To: T10 Technical Committee  
From: Rob Elliott, HP (elliott@hp.com)  
Date: 30 May 2007  
Subject: 07-091r3 SAS-2 SMP DISCOVER support for SNW-3 phy capabilities

Revision 3 (30 May 2007) Incorporated comments from May 2007 SAS protocol WG - added a NEGOTIATED SSC BIT to DISCOVER, clarified meaning of "supported" and "valid" in SNW text. Moved PHY CONTROL changes to a separate proposal. Restored supported settings priority table for the settings bits from 06-515r0 (which was missed when that proposal was incorporated into sas2r08).

**Figure 128 — SNW-3**

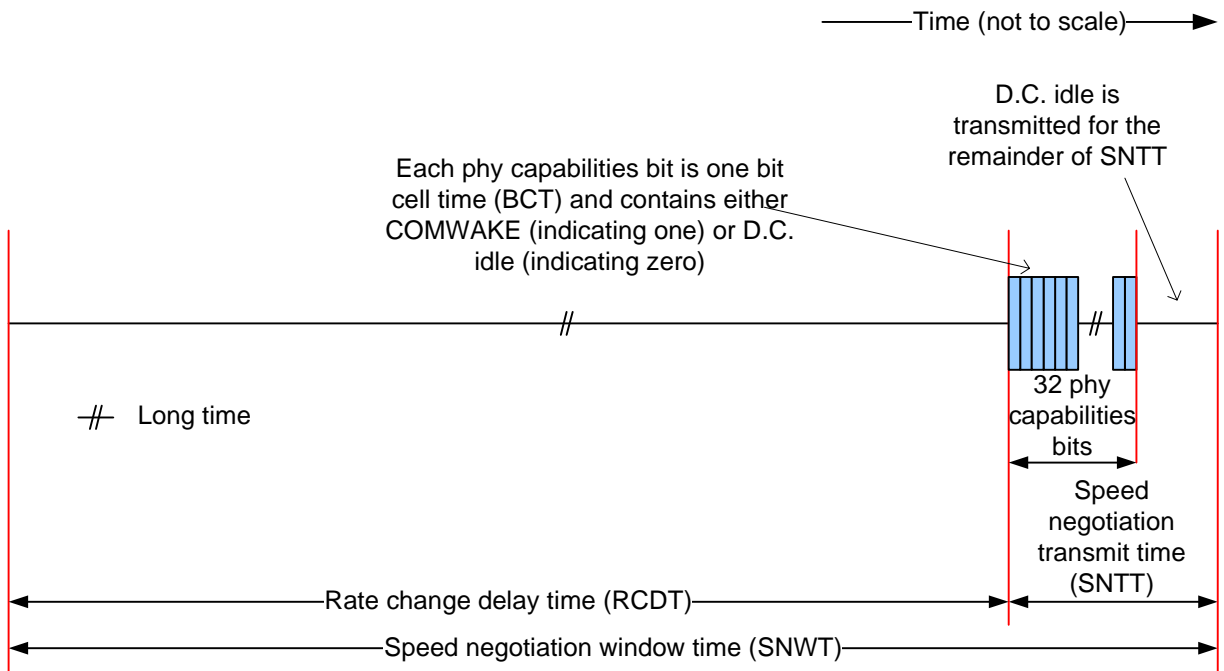
SNW-3 allows the phys to exchange phy capabilities ~~values indicating supported settings and other information to establish phy parameters used in Train-SNW.~~

- a) ~~speed negotiation window~~ SNW time (SNWT);
- b) ~~speed negotiation window rate of 1,5 Gbps;~~
- c) rate change delay time (RCDT); and
- d) speed negotiation transmit time (SNTT).

Figure 129 — Train-SNW [updated]

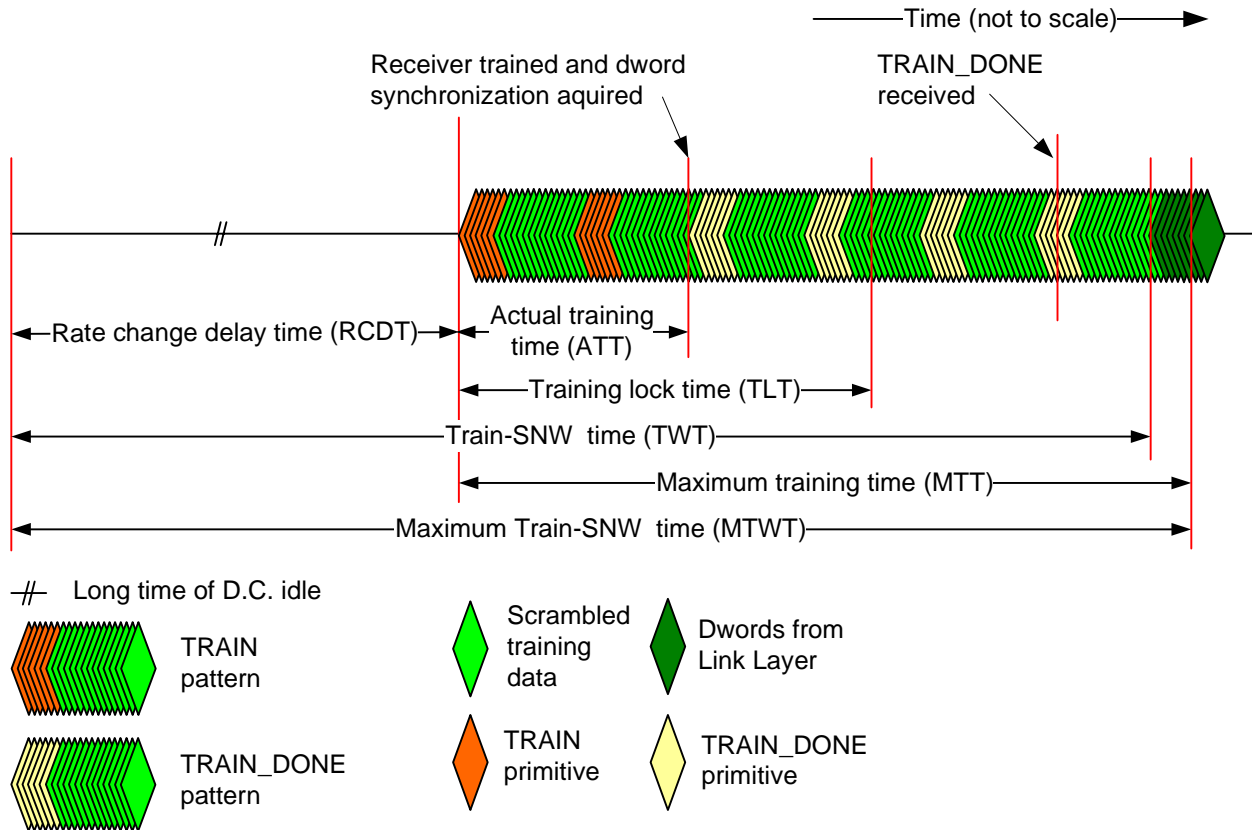
Figure 129 defines the Train-SNW, including:

- a) maximum Train-SNW window time (MTT);
- b) rate change delay time (RCDT);
- c) maximum train time (MTT);
- d) train lock time (TLT); and

**Figure 130 — SAS speed negotiation sequence SNW flowchart**

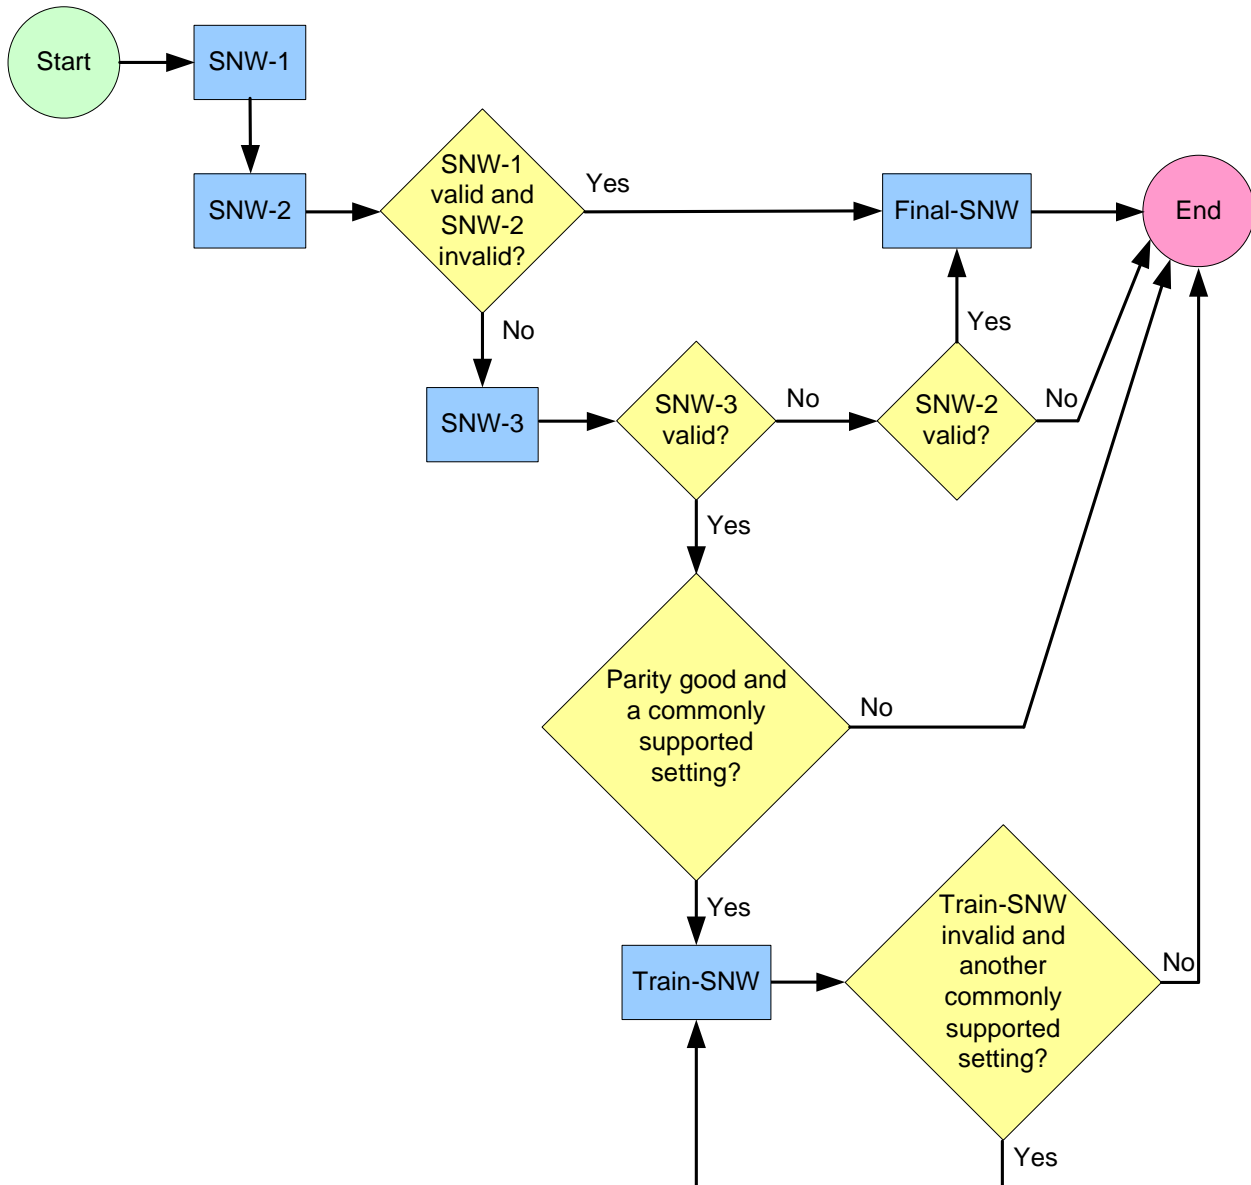
The SAS speed negotiation sequence consists of a set of speed negotiation windows (see 6.7.4.2.3) in the order shown in figure 130.

**Figure 131 — SAS speed negotiation sequence (phy A: SNW-1 through SNW-3, phy B: SNW-2 only).**  
[modified]

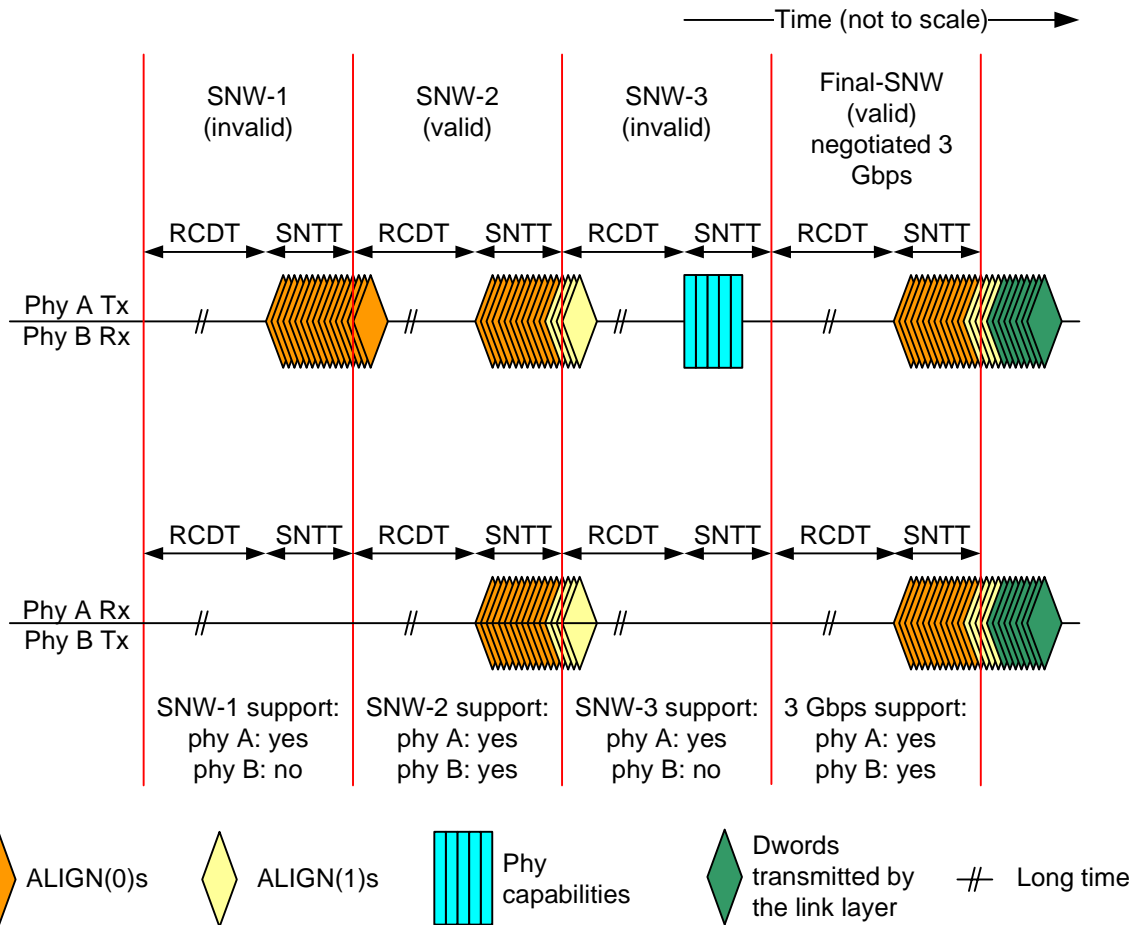
Figure 131 shows speed negotiation between a phy A and phy B where phys participate in:

- 1) SNW-1, supported by phy A but not by phy B;
- 2) SNW-2, supported by both phys;
- 3) SNW-3, supported by phy A but not by phy B; and
- 4) Final-SNW negotiating 3 Gbps.

Figure 132 — SAS speed negotiation sequence (both phys SNW-1 through SNW-3) [\[modified\]](#)

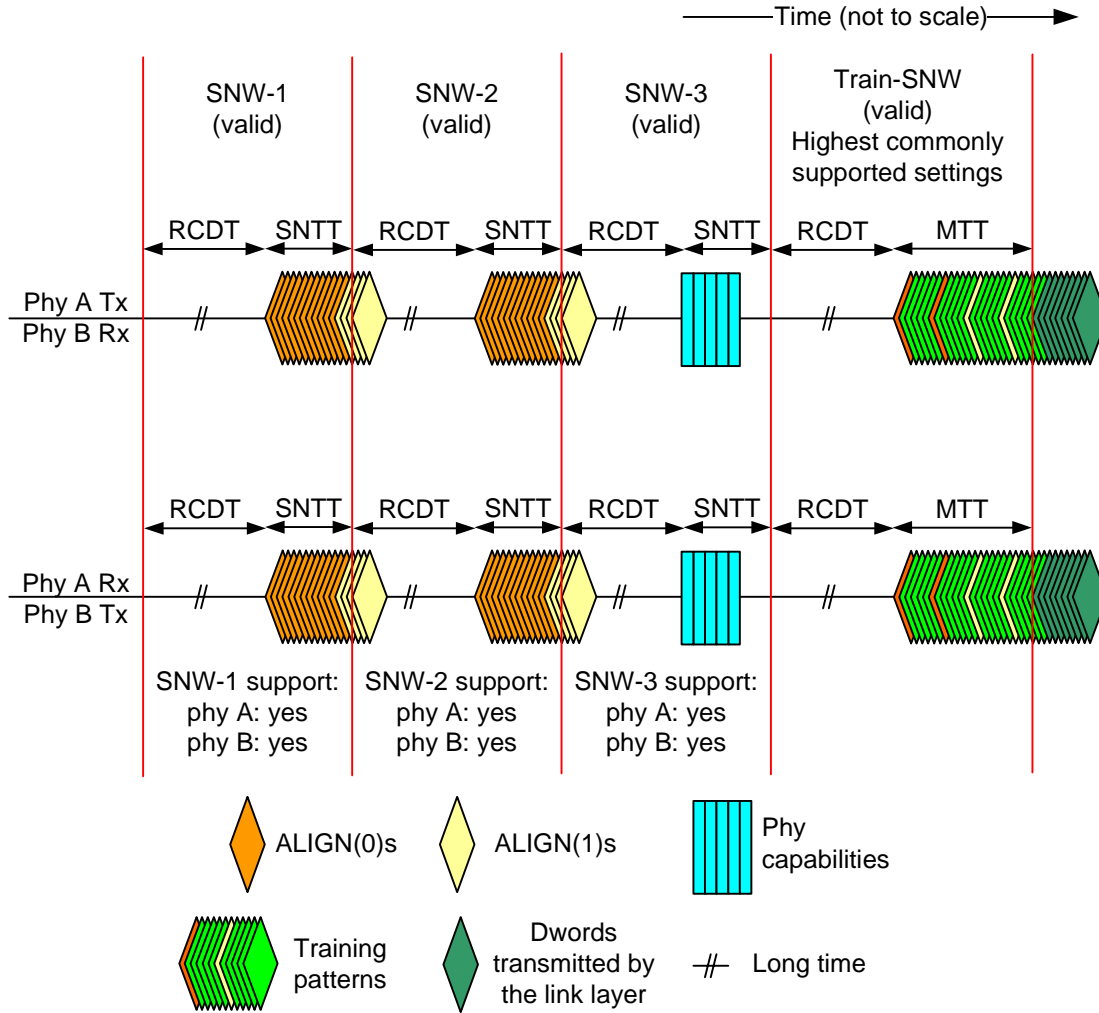
Figure 132 shows speed negotiation between a phy A and a phy B where both phys participate in:

Figure 133 — SAS speed negotiation sequence - phy reset problem in Final-SNW [modified]

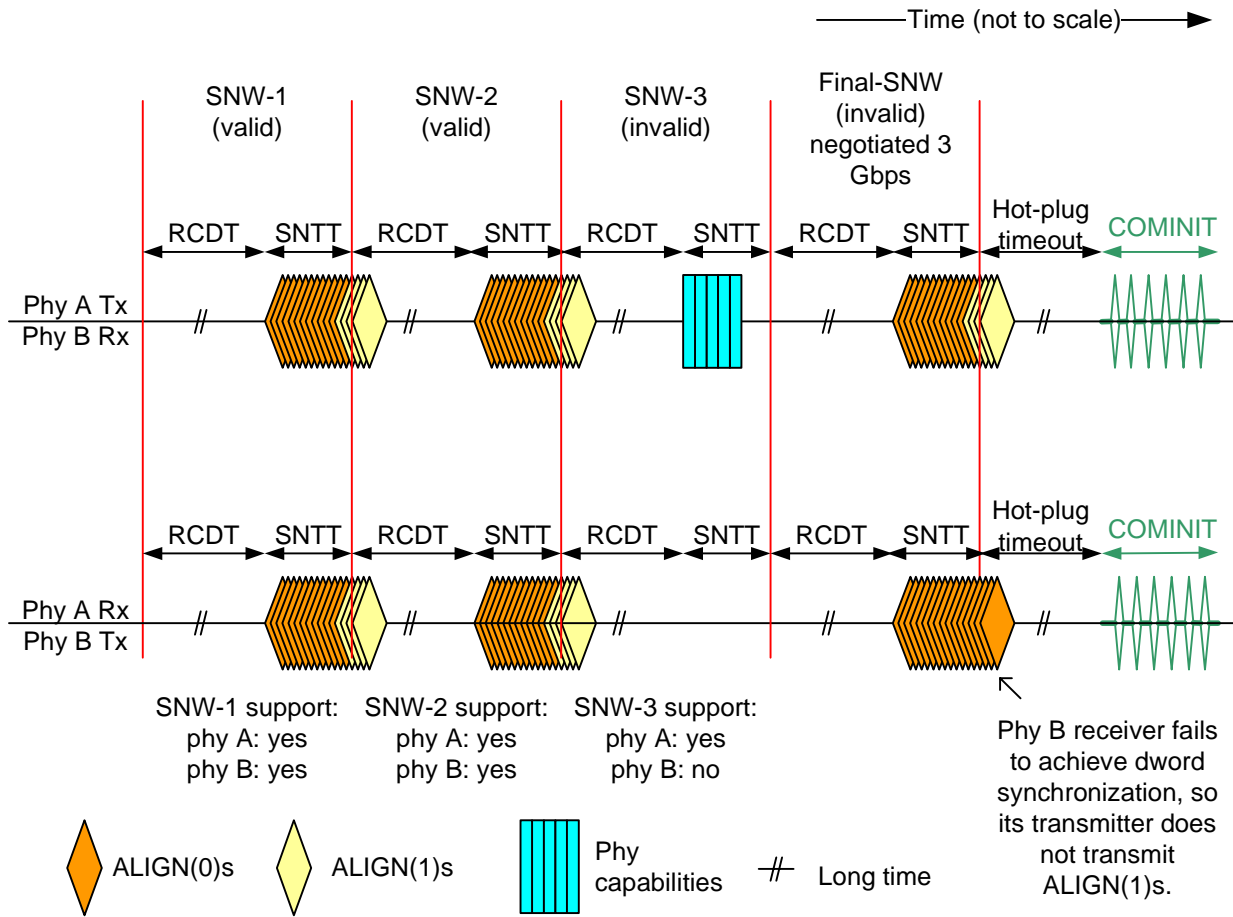
Figure 133 shows a speed negotiation sequence where phy B does not achieve dword synchronization during Final-SNW, creating a phy reset problem. If this occurs, the handshake is not complete and the phy reset sequence is retried.

Figure 134 — SAS speed negotiation sequence - phy reset problem in SNW-3 [modified]

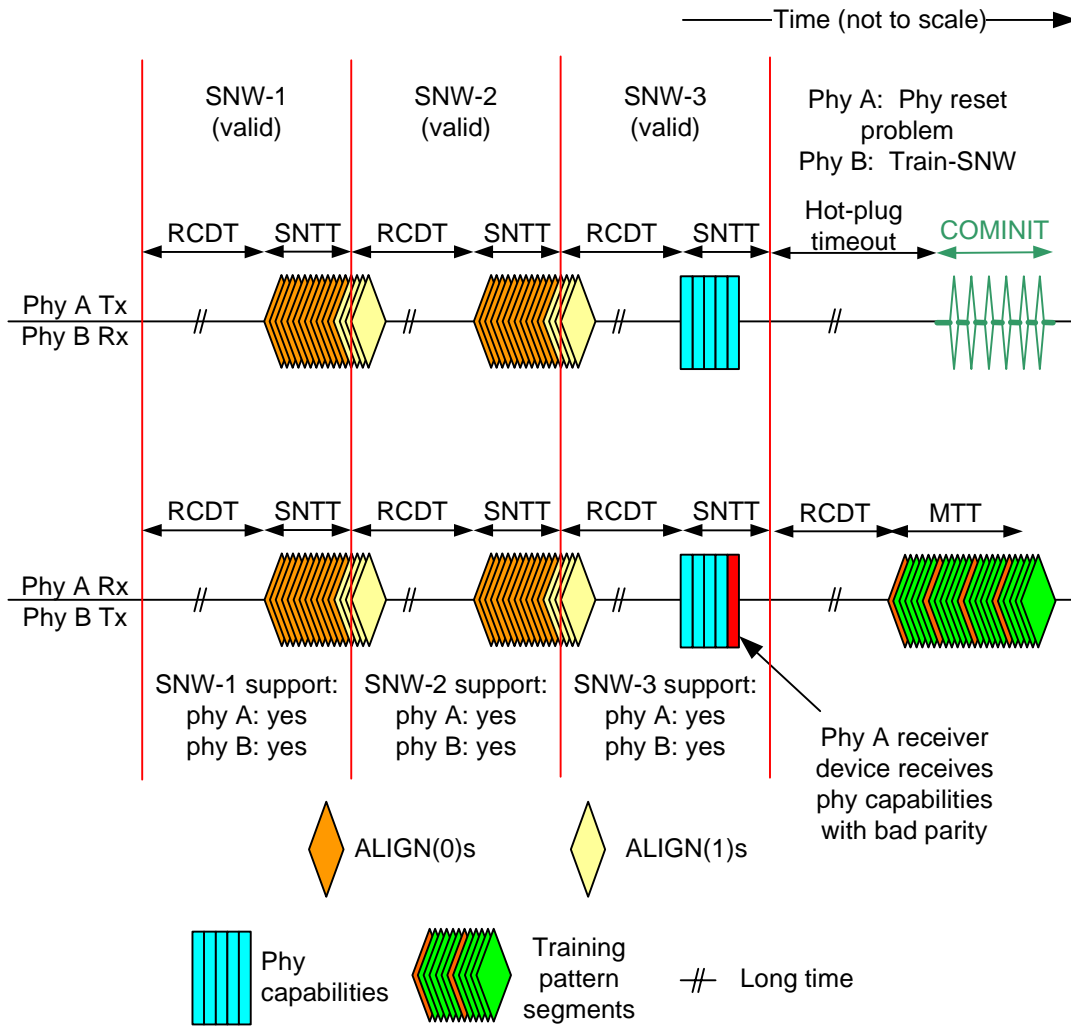
Figure 134 shows a speed negotiation sequence in which a phy reset problem is encountered in SNW-3 because the phys do not exchange the phy capabilities bits properly (e.g., due to a parity error).

Figure 135 — SAS speed negotiation sequence - phy reset problem in Train-SNW [\[modified\]](#)

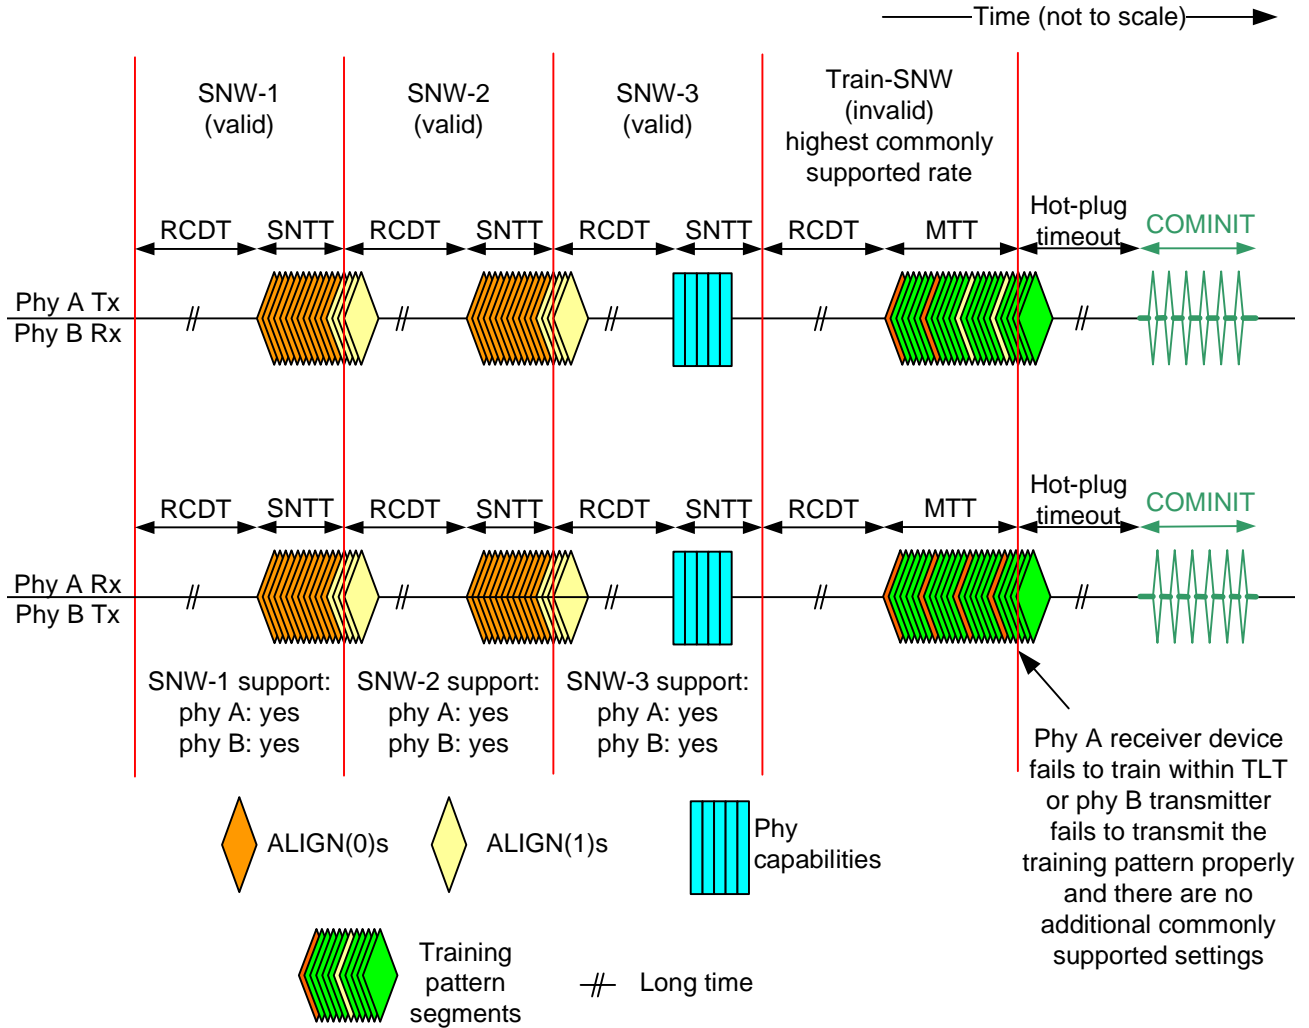
Figure 135 shows a speed negotiation sequence in which a phy reset problem is encountered in Train-SNW because either phy does not complete training within the MTT interval of several training windows exhausting all commonly supported settings exchanged in SNW-3.

Figure 136 — SAS speed negotiation sequence - multiple Train-SNWs [modified]

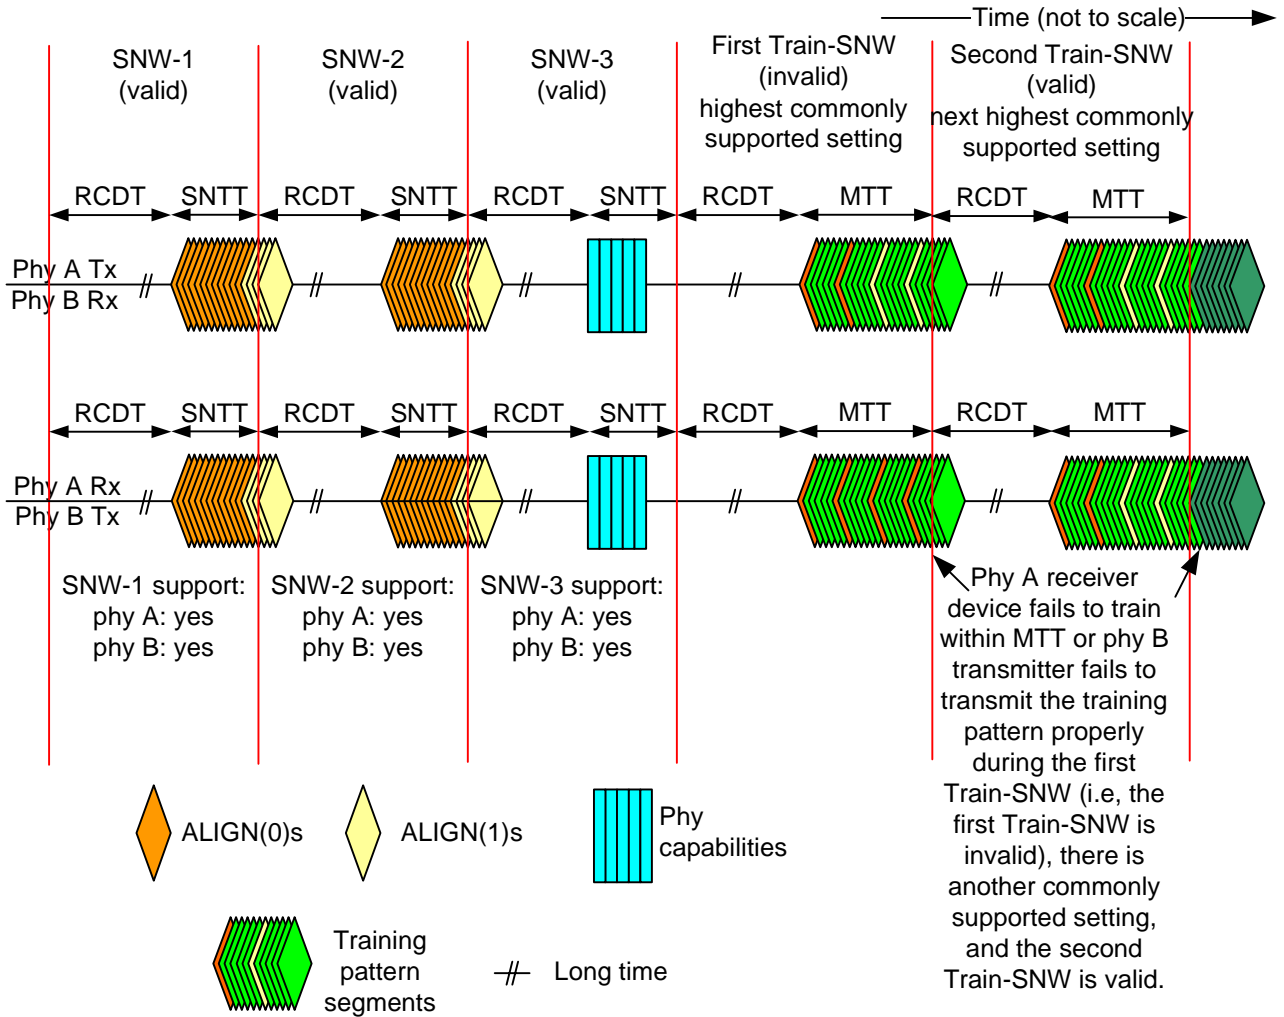
Figure 136 shows two Train-SNWs, if supported settings bits are exchanged that contain more than one commonly supported setting and the Train-SNW using the highest commonly supported setting is invalid, a second Train-SNW is performed using the next highest commonly supported setting.
